# GRANDVIEW RESERVE PHASE 2 PUD DEVELOPMENT PLAN & PRELIMINARY PLAN

# V3\_PUDSP.pdf Markup Summary

SHEET  
**ADJ**      03

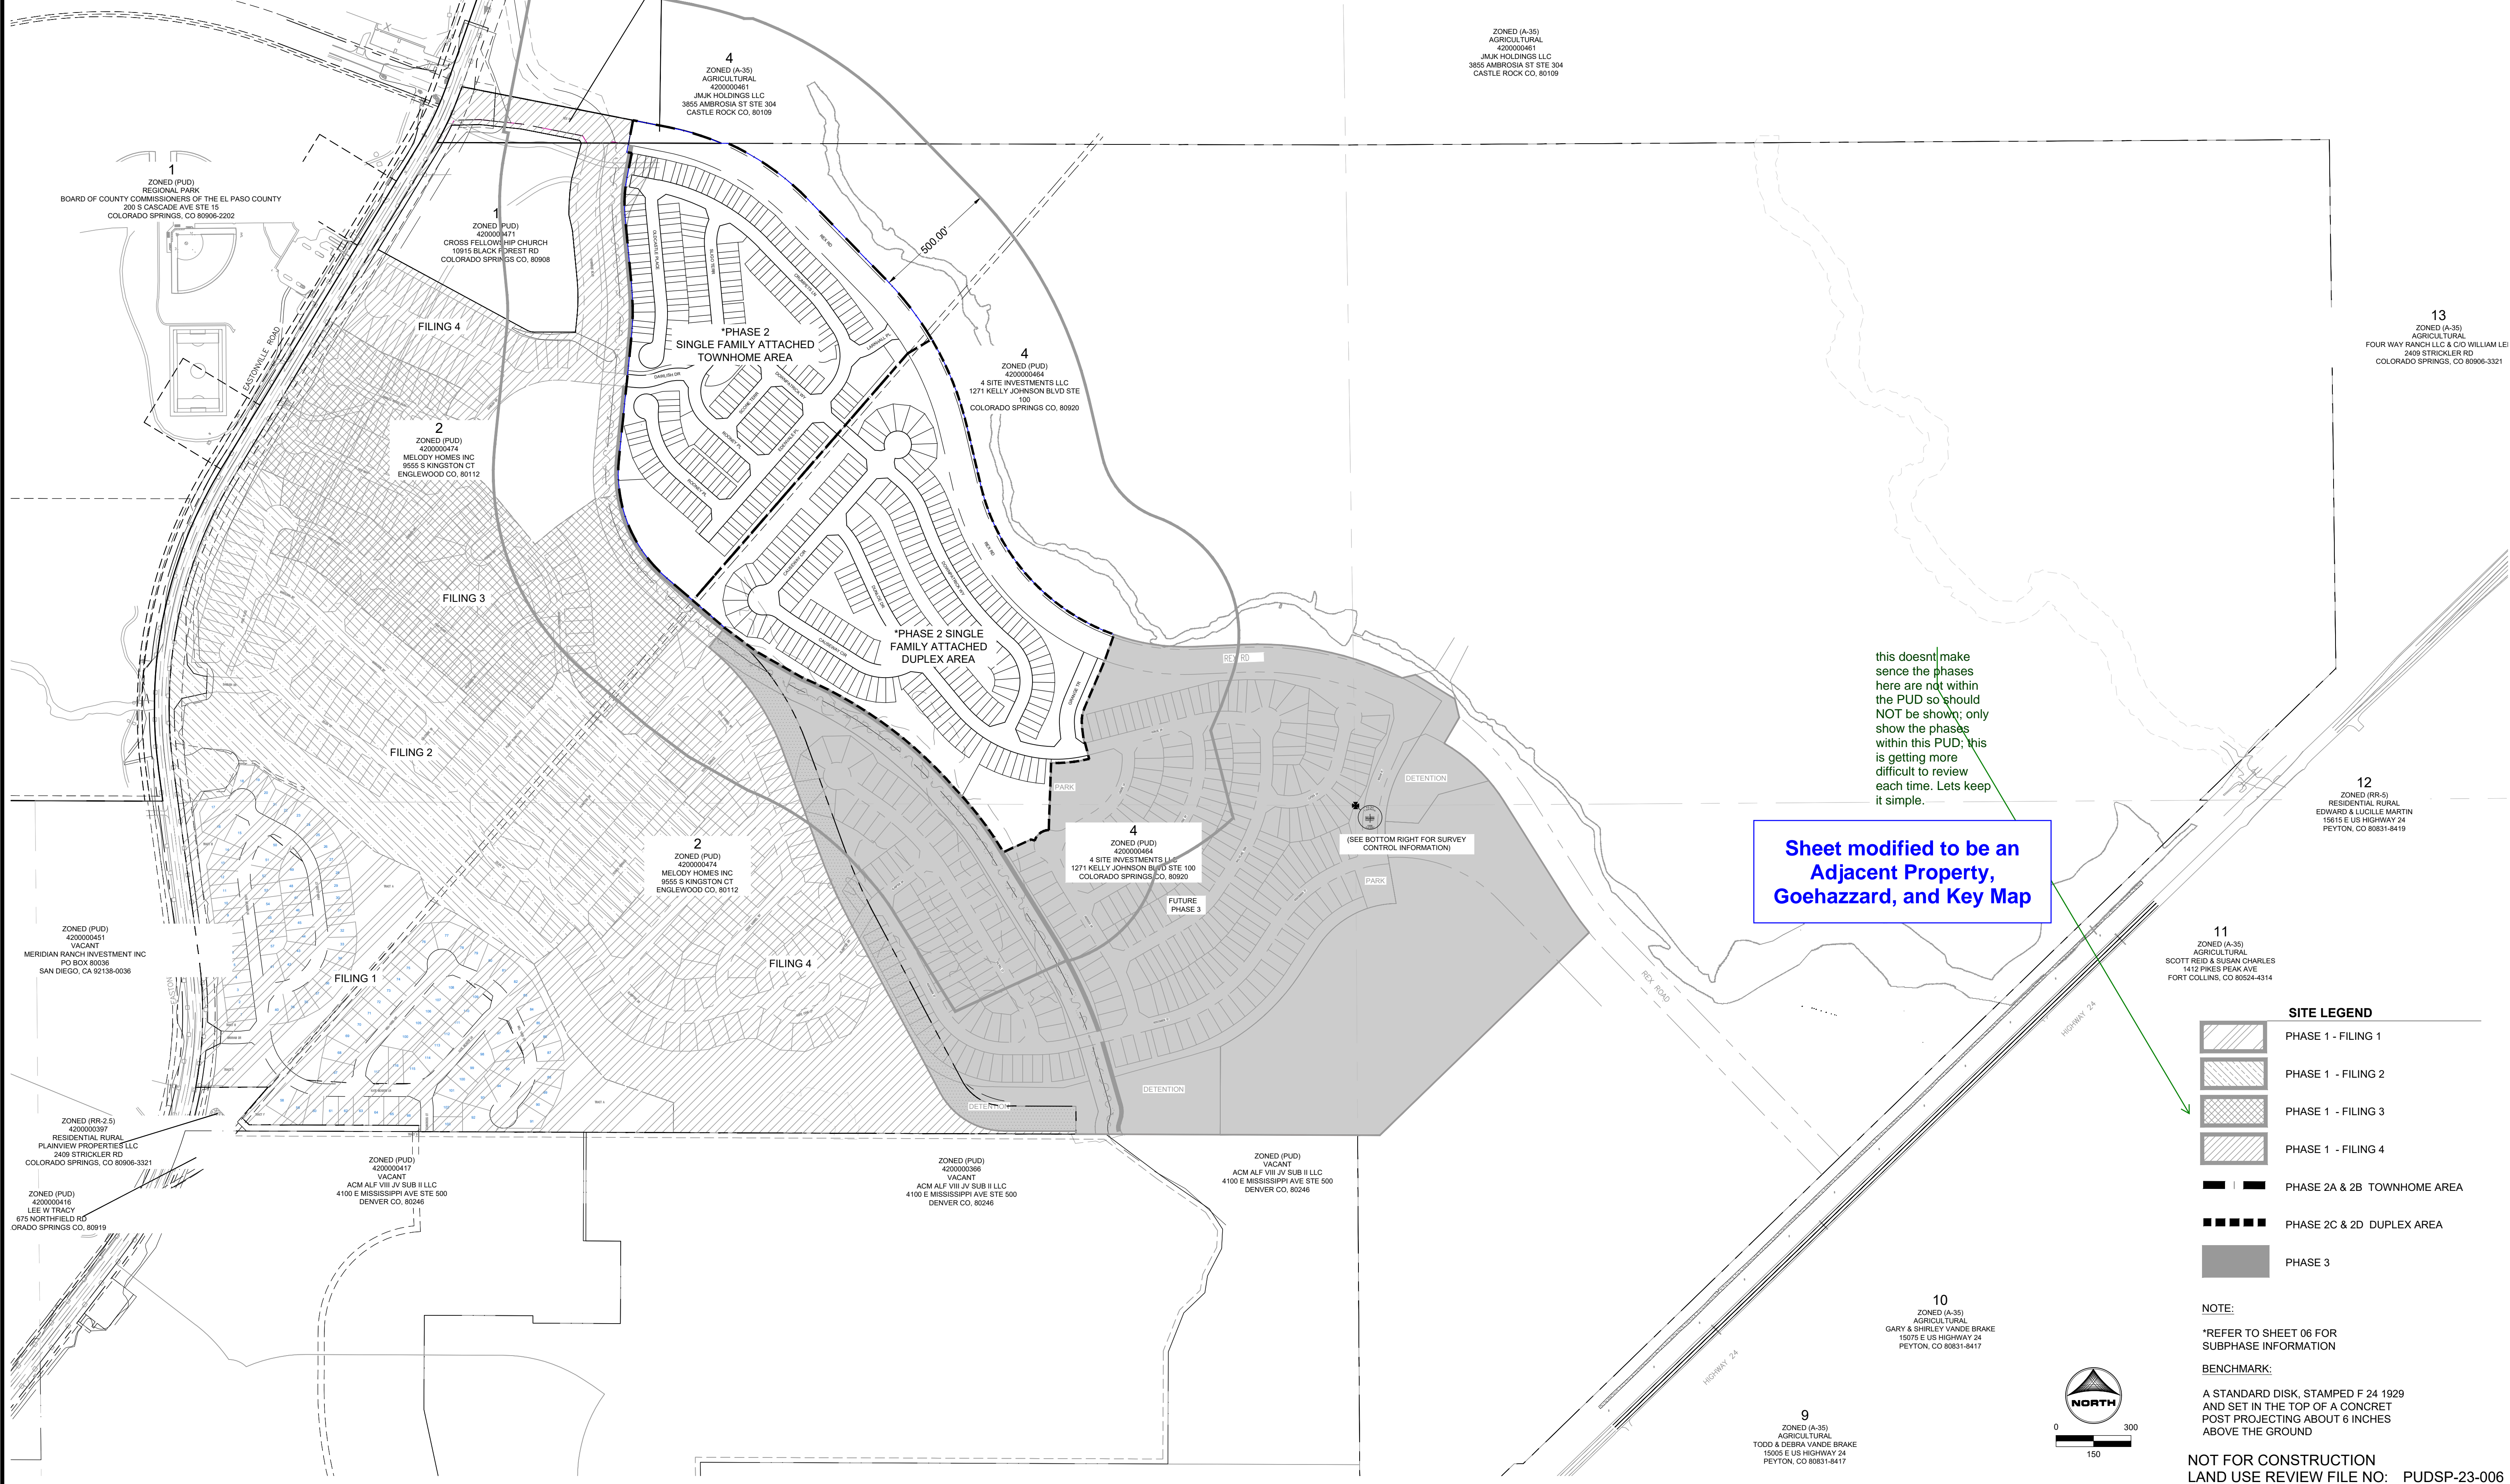
this doesn't make sense the phases here are not within the PUD so should NOT be shown; only show the phases within this PUD; this is getting more difficult to review each time. Lets keep it simple.

Sheet modified to be an Adjacent Property, Goehazard, and Key Map

SHEET TP 04

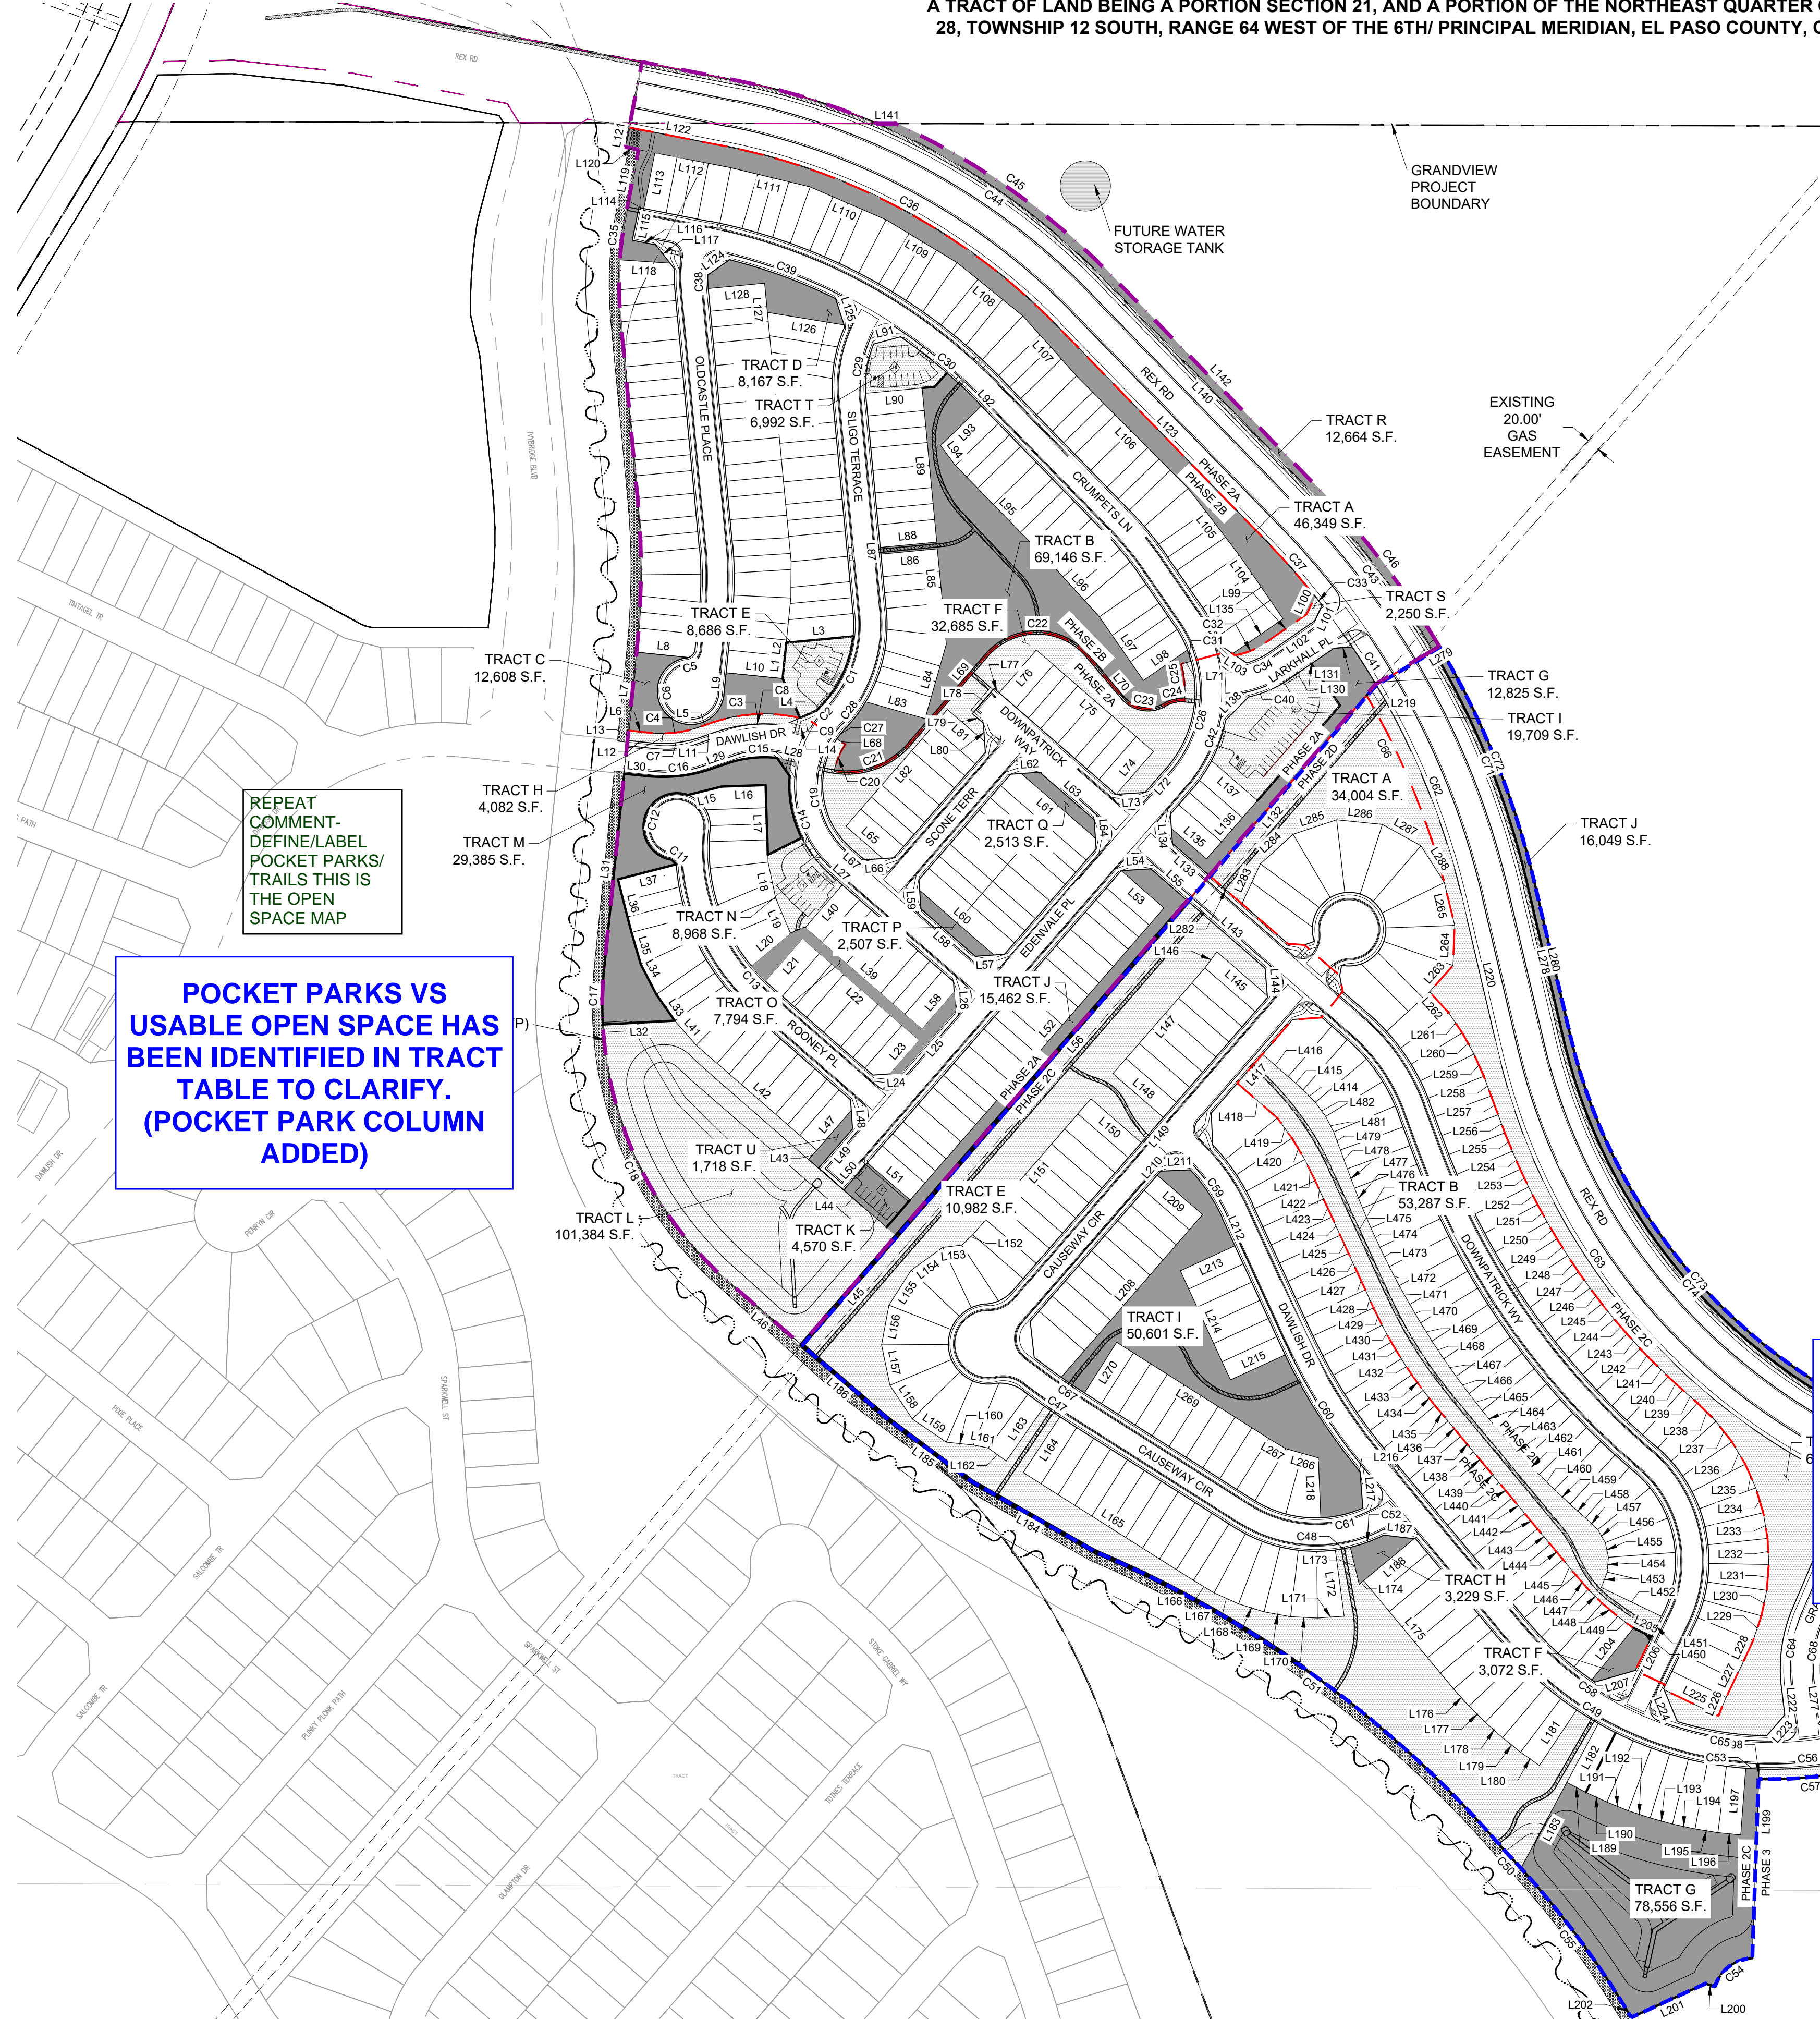
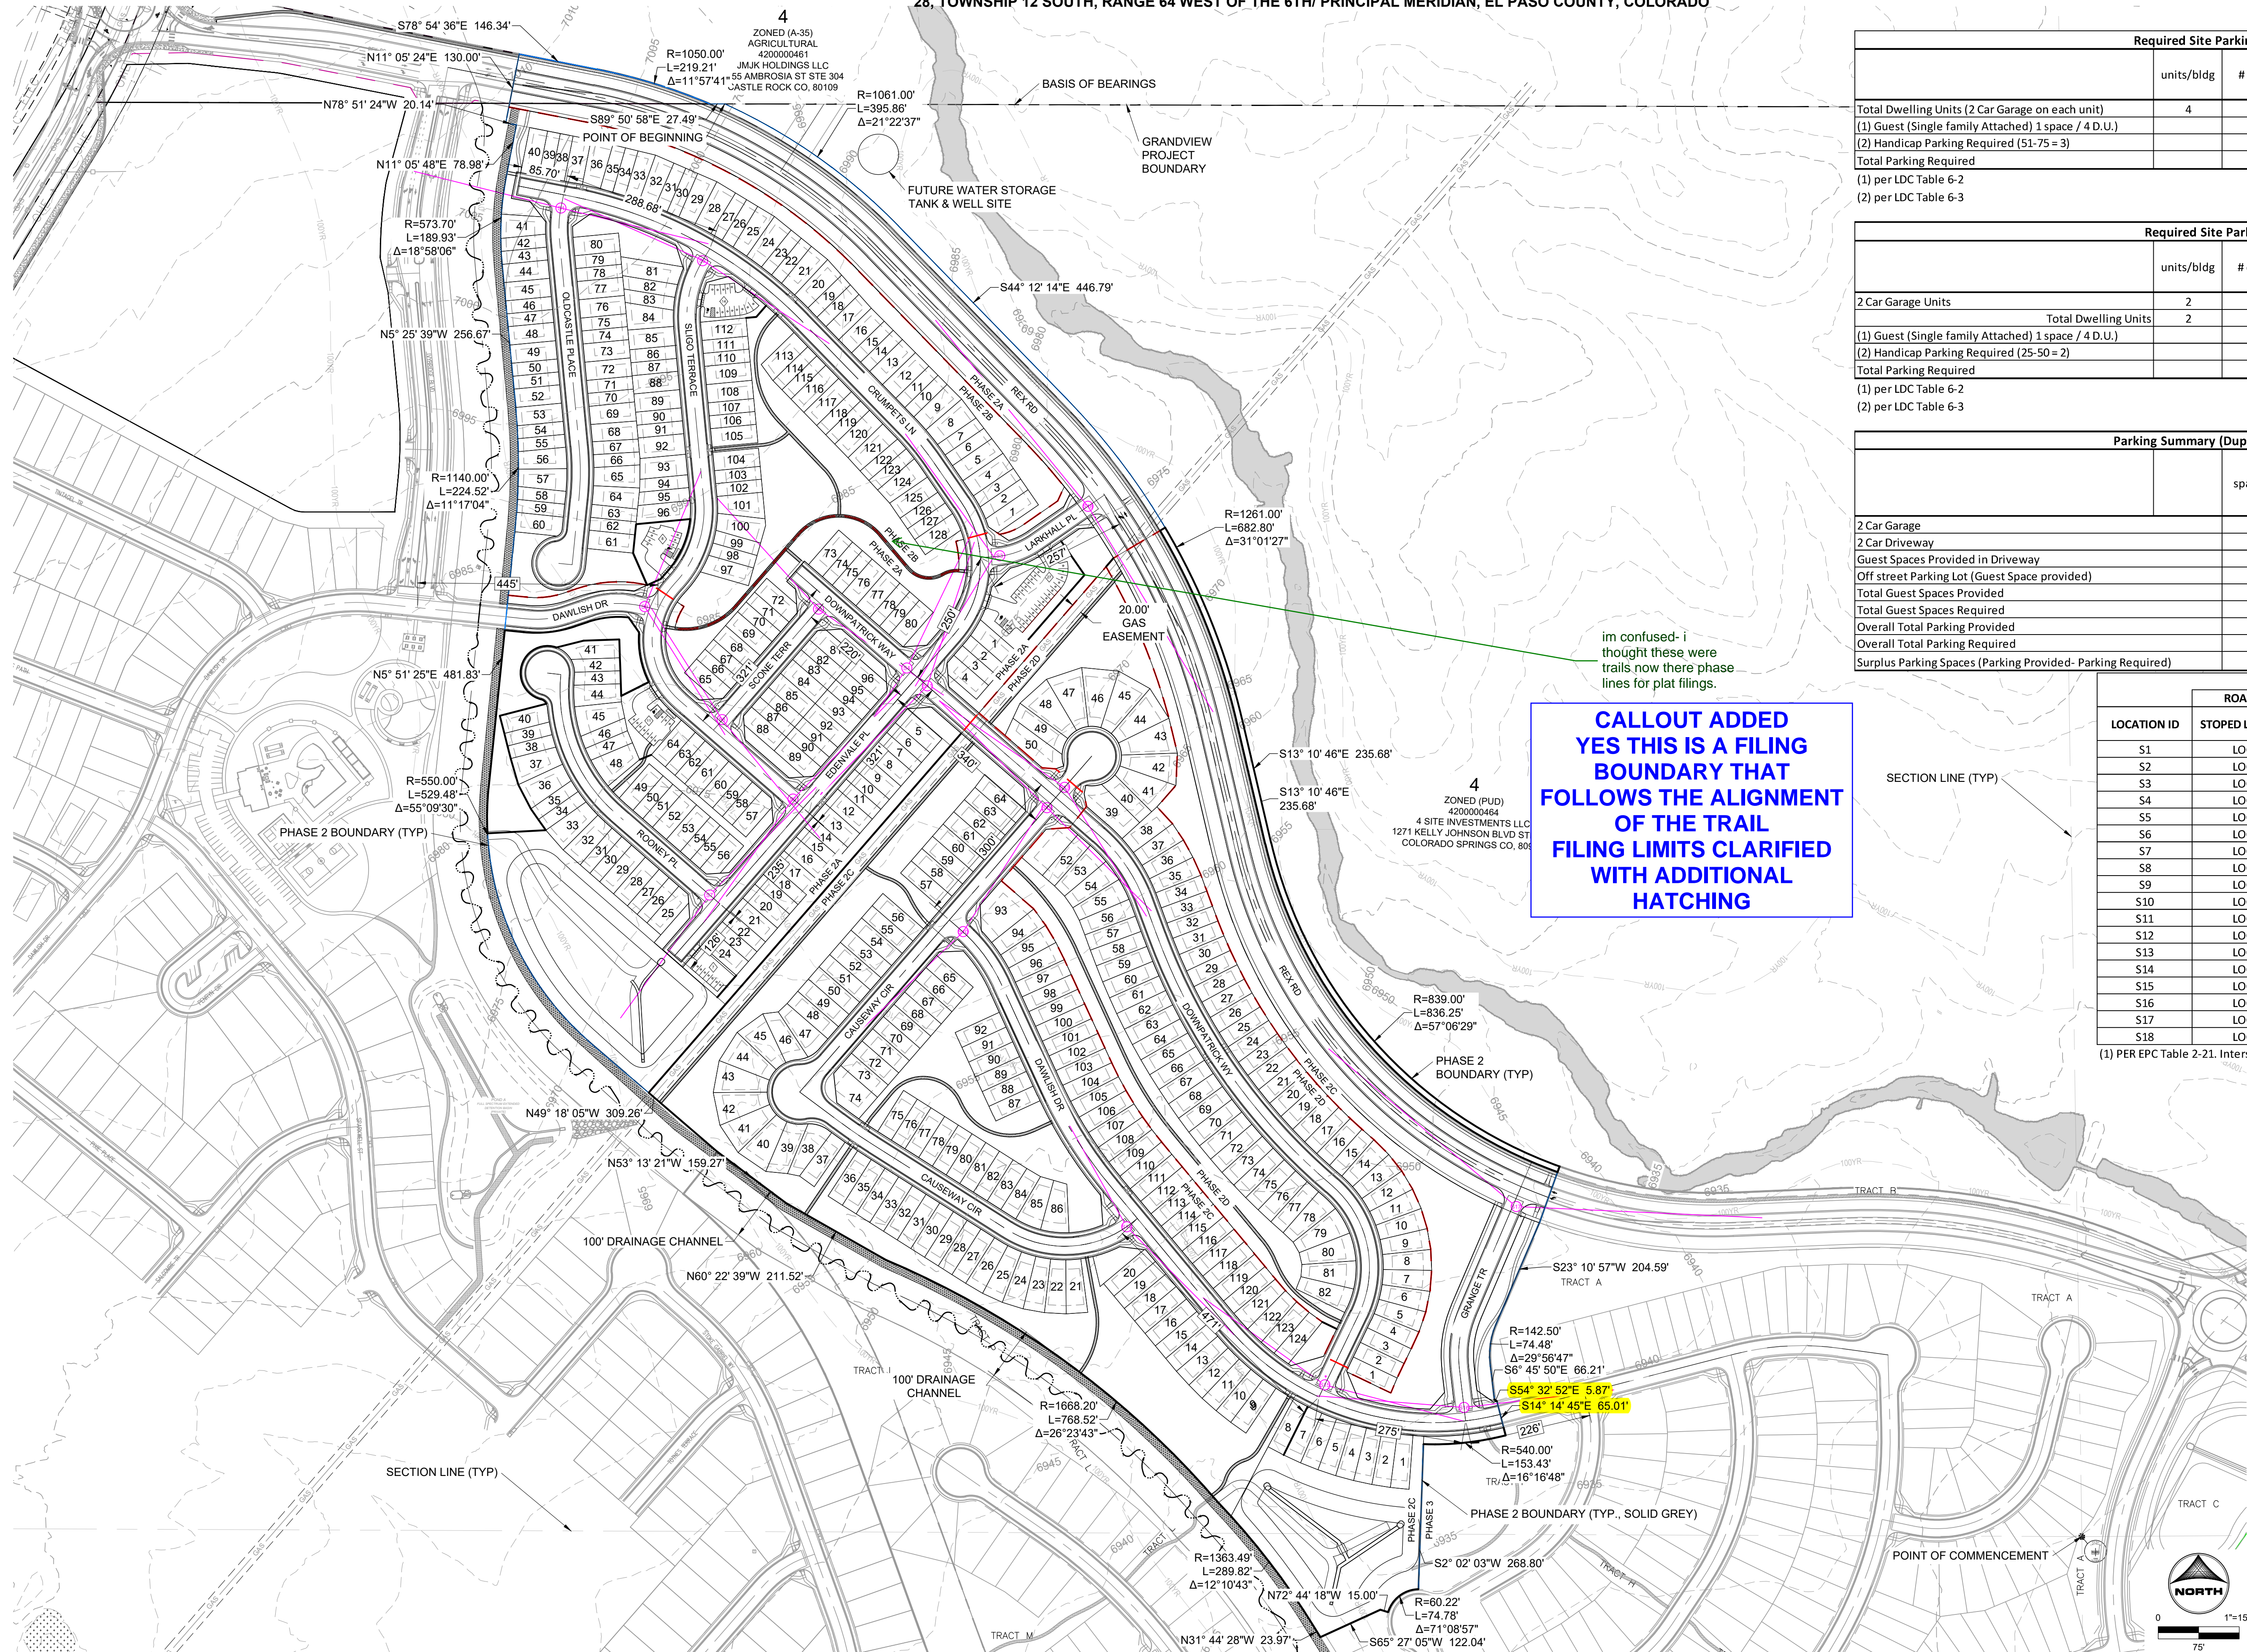
REPEAT COMMENT-DEFINE/LABEL POCKET PARKS/TRAILS THIS IS THE OPEN SPACE MAP

label over label; what is contrast 1 mean? are these differentiating between uses?

DELETE this - this would not be correct if you were proposing plats within the preliminary plan. Plats has to have roads to get to them and tracts etc... just add a note multiple plat filings are anticipated within preliminary plan.

**POCKET PARKS VS USABLE OPEN SPACE HAS BEEN IDENTIFIED IN TRACT TABLE TO CLARIFY. (POCKET PARK COLUMN ADDED)**

**NOTE ADDED TO DEFINE DIFFERENCE BETWEEN HATCH AREAS: HATCHED AREAS DISTINCTLY DIFFERENTIATE BETWEEN ADJACENT TRACT AREAS. THIS IS FOR PLAN CLARITY ONLY**

**REDIFINED AS FILING LINE. THE FILING LIMITS HAVE BEEN ESTABLISHED SUCH THAT ROAD ACCESS IS PROVIDED WHEN BUILT IN SEQUENCE. NOTE REGARDING FILING PROVIDED ON SHEET 6**
